CENTRAL DELTA WATER AGENCY

Re: BDCP/California Water Fix
RDEIR/SDEIS
DJN Sr. Part Four

Comments on the Revised Public Draft BDCP EIR/S - Additional Central and South Delta Water Agency Comments

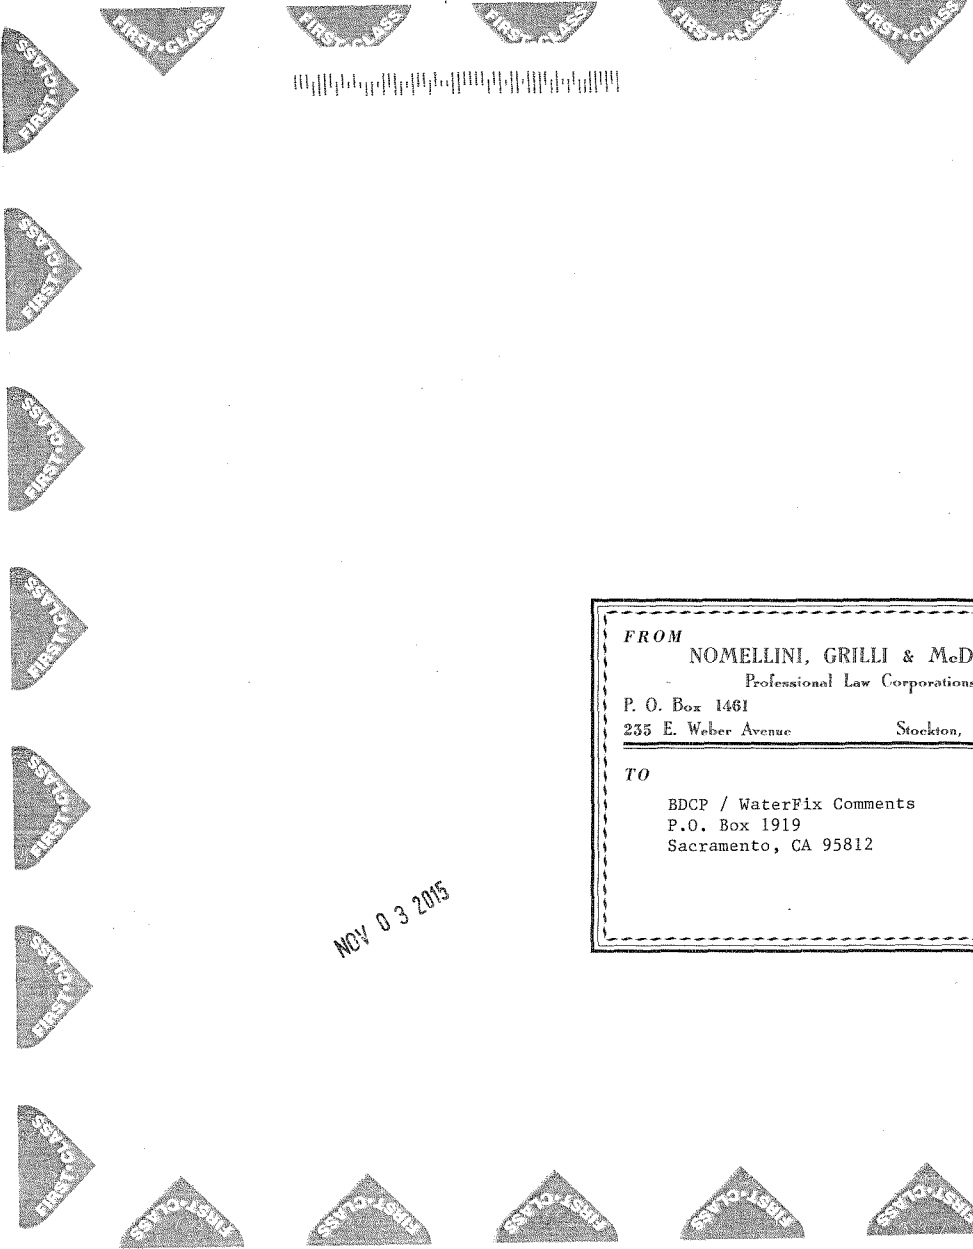
Comment continued: Here are the basic elements to this Clifton Court criteria compliant fish screen alternative component: widen the Clifton Court operable gates, install trash racks outside the operable gates, install a course large fish exclusion screen between the trash racks and operable gates, construct a conveyance channel in Clifton Court Forebay from the operable gates to the western side of Clifton Court Forebay, install criteria compliant fish screens in the conveyance channel, reengineer the current fish salvage facilities, and plumb the CVP intake into the fish free north side of Clifton Court via a short tunnel. Following is a more detailed description of each of these elements.

Comment continued: Widen the Clifton Court Forebay operable gates to the north from their existing location. The width of the new operable gates needs to be sufficient to create a channel cross section of about 15,000 square feet. Dredge and reinforce channels as most economical and reliable from an engineering standpoint. As an example, dredge the approach and channel at the operable gates to a tidal working channel depth of 30' for a total operable gate width of 500'. The new gates should be set back into Clifton Court sufficiently to allow installation of trash racks and course large fish exclusion screens in front of them without reducing the existing channel cross section outside of Clifton Court. The Clifton Court Forebay Gates and tidal operations/storage can continue to function as they do under the existing conditions and No Action/Project so there are no operational impacts from this alternative component on tidal operations of Clifton Court Forebay.

Comment continued: Install trash racks outside Clifton Court Forebay outside of the widened Clifton Court operable gate. The trash racks will intercept debris coming in with the diversion water and serve as a behavioral deterrent to the fish to stay in the main channel as much as possible.

Comment continued: Behind the trash racks and just in front of the operable gates would be a course fish screen designed to keep out only larger "predator" size fish that have much higher swimming performance capability from entering Clifton Court Forebay. With the new 15,000 square foot cross section of the operable gates and surface area of the course fish screens, at full capacity CVP/SWP diversions the approach velocity at the course fish screens would be one foot per second. Predator sized fish would easily out swim this approach velocity, but smelt and juvenile salmonid would be pulled through and past the course large fish exclusion screen. There would be some predation at the trash racks and course fish screens but this can be managed and reduced with predator removal actions and fish traps. The level of predation at the trash racks and course fish screens would be the same as the predation rates that occur at the current SWP trash racks and fish louvers under the No Action. This course fish screen outside of Clifton Court Forebay is designed to pass smelt and juvenile salmonids without risk of impingement, e.g. 15 - 25mm wide screen inlets. This screen would significantly reduce the exposure of juvenile salmonids and delta smelt to predation as larger predators would be excluded from within Clifton Court Forebay where a large amount of current predation is documented to occur.

Comment continued: A conveyance channel would be created in Clifton Court Forebay by segmenting the northern and southern parts of the Forebay with a new sheet pile partition that would draw water from the Clifton Court Forebay operable gates channel directly toward the existing SWP intakes on the southwestern side of the Forebay. The conveyance channel would start at the east side of the Forebay at the north and south ends of the widened operable gates channel. The partition would then quickly (but maintaining orderly water flow vectors) narrow from 500' wide to a width of approximately 250' wide and deepen from the initial 30' channel depth at the operable gates to a conveyance channel depth of 60 feet deep. The rest of the length of the conveyance channel would be dredged to a 60 feet deep with the channel partitions reinforced as necessary for stability. The channel depth is to accommodate the large surface area of fish screens and to increase the channel cross section to reduce water velocities. The channel would speed the transit of the fish across the Forebay (as compared to the No Action) and keep them from straying out into the Forebay so that they would have a significantly reduced duration of exposure to predation. Fish predation studies of the current Forebay operations have shown that a large portion of the juvenile salmonid and delta smelt population that enter the Forebay do not make it to the salvage facilities due to predation. By excluding predator size fish from entering Clifton Court, not allowing the smelt and juvenile salmonid fish to stray into the larger part of the Forebay and by shortening the duration and distance of their transit across the Forebay prior to capture and salvage; predation rates on juvenile salmonids and delta smelt would be significantly reduced with the Clifton Court criteria compliant fish screen alternative as compared to the existing condition, No Action/No Project or in comparison to any of the other alternative which retain dual operations without south delta intake screens that are criteria compliant.

Comment continued: Install criteria compliant fish screens in the conveyance channel in Clifton Court Forebay. Orient the screens in the conveyance channel in a "deep V" (10 to 15 degree angle) across the Clifton Court Conveyance Channel with the bottom of the V in the middle of the new conveyance channel approximately 1/4 mile from the west side of Clifton Court Forebay. The fish screens would be oriented vertically on the sides of the V. The top of the V is on the east side of Clifton Court Forebay and is attached to the sides of the conveyance channel partitions where the channel comes to approximately 250 feet wide. Each side of the V fish screen would be approximately 6850 feet long with a depth of 60 feet for a total working surface area in their vertical orientation of 822,000 square feet. If greater surface area is desired, alternative designs where the screens are sloped in towards the middle of the conveyance channel at the bottom can be evaluated for cost, operational flexibility and fish protection performance. The deep V shape of the screen orientation in the conveyance

Comment continued: As an example, water approaching a screen at a 15 degree oblique angle has an approach velocity that is 3.5% of the sweeping velocity. With the conveyance channel at 250 foot wide and 60 feet deep, at maximum CVP/SWP diversion volumes of 15,000cfs the water column velocity in the conveyance channel would be one foot per second. With a water column velocity of 1 foot per second, a 15 degree angled V screen would result in a sweeping velocity of 0.965 feet per second and an approach velocity of 0.035 feet per second.

Comment continued: The total surface area of vertically oriented deep V fish screen configuration is 822,000 square feet with the above assumptions. (As previously mentioned, sloped screen designs could have even larger surface areas if desired.) At the maximum combined CVP/SWP volume of 15,000 cfs the approach velocity to screens with this large surface area is just over 0.018 feet per second. 0.2 foot per second screen approach velocity is the compliance criteria for delta smelt so the fish screens as described would be only be 10% of the maximum approach velocity for smelt at the maximum CVP/SWP intake volume operations. If this screen configuration is considered over-designed with the 10% of the allowed approach velocity criteria and is excessively protective, and a more relaxed (but still compliant) approach velocity is deemed by the fisheries agencies to be adequately protective, the channel depth could be reduced along with the fish screen height and a narrower channel with a shorter length fish screen could be applied and still easily meet the fish screen criteria requirements. As an example a fish screen only 30 feet deep and half as long would still result in approach velocities that were half as fast as are delta smelt criteria compliant.
